GOVERNMENT OF THE DISTRICT OF COLUMBIA  
DEPARTMENT OF TRANSPORTATION

**MEMORANDUM**

**SUBJECT:** BZA Case No. 19079 – 2000-2002 11th St NW

Figure 1. Proposed Site Plan (Source: Applicant)

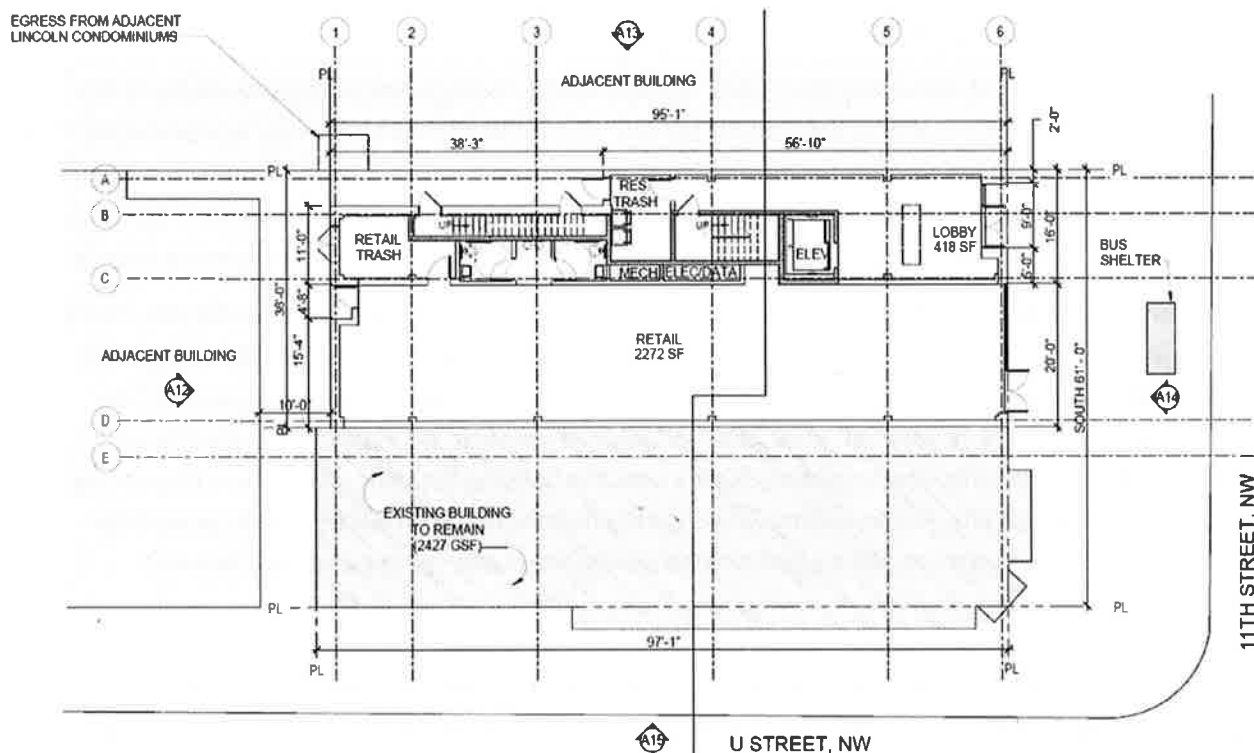
The proposed building is not providing vehicular parking spaces, however is required by zoning regulation to provide 17; one for every three residential units and six spaces for retail use.

DDOT's practice is to accommodate vehicle loading in a safe and efficient manner, while at the same time preserving safety across non-vehicle mode areas and limiting any hindrance to traffic operations. For new developments, DDOT standards require that loading take place in private space and that no back-up maneuvers occur in the public realm. This often results in loading being accessed through an alley network or an approved loading location. Here, however, the Site does not have access to an alley suitable for loading. Therefore, it will be necessary for loading activity for the site to take place nearby on-street.

While not part of this zoning action, a workable loading concept was provided to show this building can be later permitted as part of the public space permitting process. The Applicant estimates that the building will see up to four van-sized deliveries, one 30-foot truck, and two trash pickups per day. These activities will occur curbside on 11<sup>th</sup> Street for residential deliveries, but will mostly utilize U Street for retail deliveries, residential move-ins, and trash pickup. Loading activity on 11<sup>th</sup> Street will be required to avoid the existing bus stop in front of the building. Loading on U Street will utilize the narrow (eight-foot) alley for moving items by hand to service entrances at the rear of the building. No loading zones currently exist at these locations.

DDOT expects the Applicant to comply with DDOT's standards for loading, the details of which will be addressed further, as necessary, as part of the permitting process for this property. The Applicant will be expected to prepare a robust loading management plan at that time.
